Staff Report
City of Richmond, Virginia

Commission of Architectural Review

12. COA-164402-2025	Conceptual Review	Meeting Date: 4/22/2025
Applicant/Petitioner	Will Gillette	
Project Description	Construct two single-family attached dwellings	
Project Location		
Address: 3021 & 3023 E Franklin St, Richmond, VA 23223		
Historic District: St. John's Church		
<p>High-Level Details:</p> <p>The applicant proposes the construction of two three-story single-family attached dwellings on a subdivided lot that currently contains a multifamily structure at 3025 E Franklin Street, and the vacant portion at 3021 E Franklin Street (noting that the 3025 E Franklin lot has been split, which created the parcel known as 3023 E Franklin).</p> <p>The surrounding context features a combination of early 20th-century rowhomes, recent infill development, and several vacant parcels. The proposal seeks to infill one of these vacant portions with townhome-style dwellings that respond to the district's narrow unique topography and urban character. The project includes cementitious lap siding, front porches, and a mansard-style roof.</p>

Figure 1

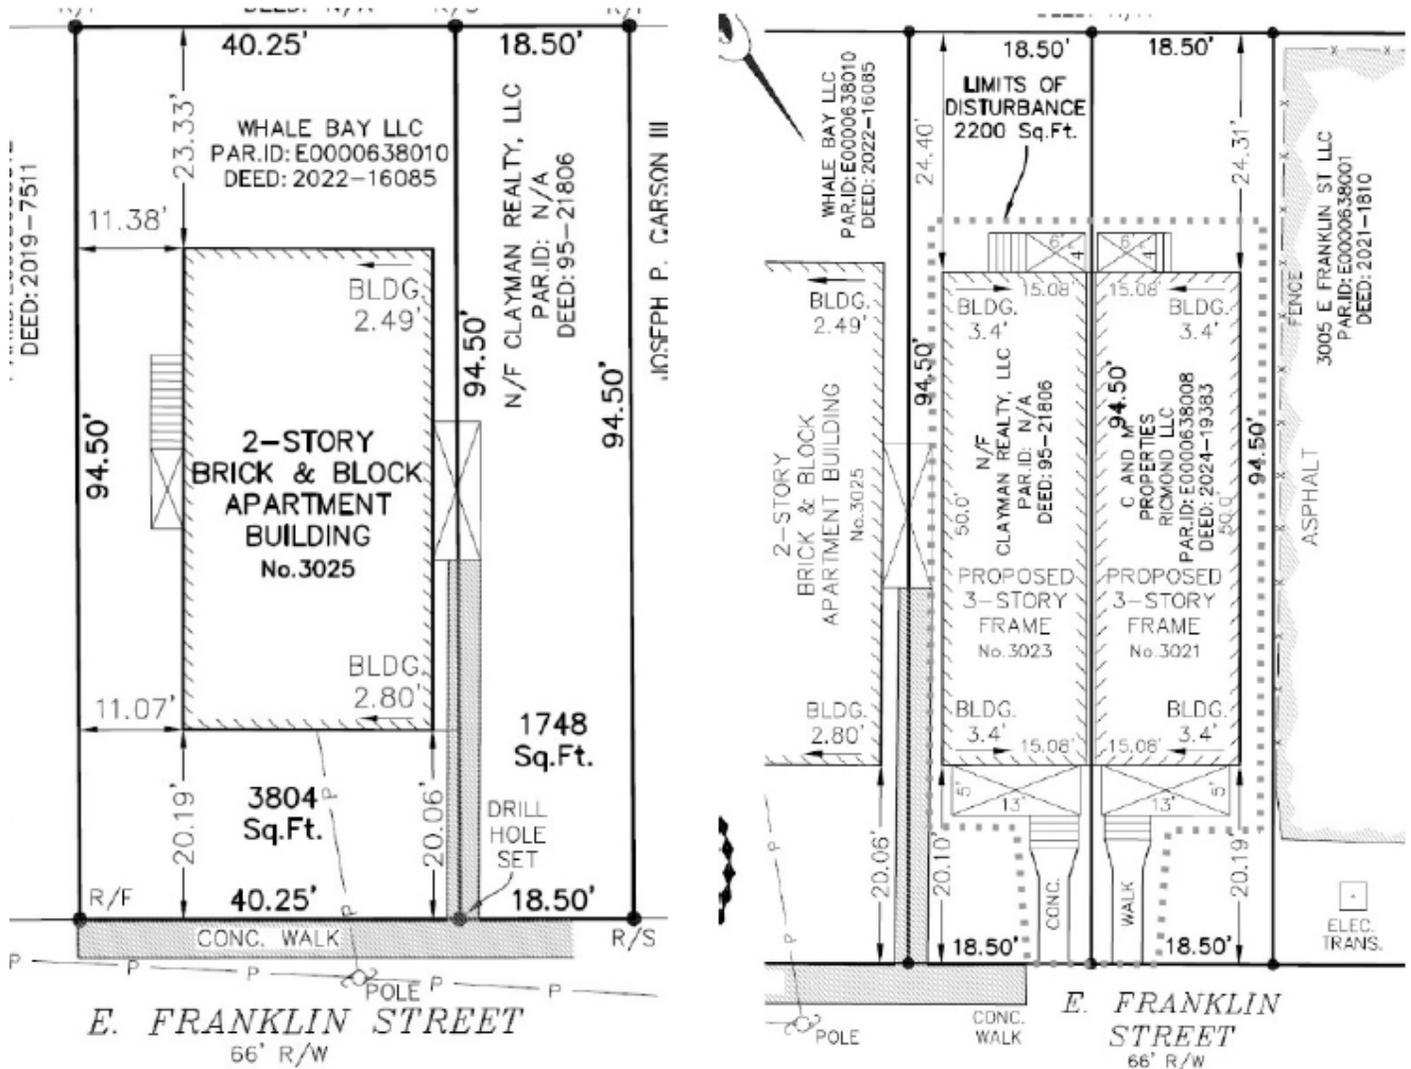
Surrounding Context		
<p>The project site is located on the south side of East Franklin Street near its intersection with North 31st Street, at the lower end of a steep slope within the St. John's Church Old and Historic District.</p> <p>The surrounding context includes one contributing two-story historic structure on the north side of the street, which appears to have influenced the scale and form of nearby new construction. The rest of the block contains several vacant lots and recently built three-story residential dwellings that reference historic massing and materials. Directly southeast of the subject parcels is a two-story multifamily building, and immediately to the west is a large mid-20th-century apartment complex at 3005 E Franklin Street, which has undergone recent renovation.</p>		
Guideline Reference	Reference Text	Analysis
New Construction: Siting, p.46	2. New residential infill construction should respect the prevailing front and side yard setback patterns of the surrounding block.	The 20' setback aligns with adjacent historic buildings and appears appropriate within the block context (Figure 1).
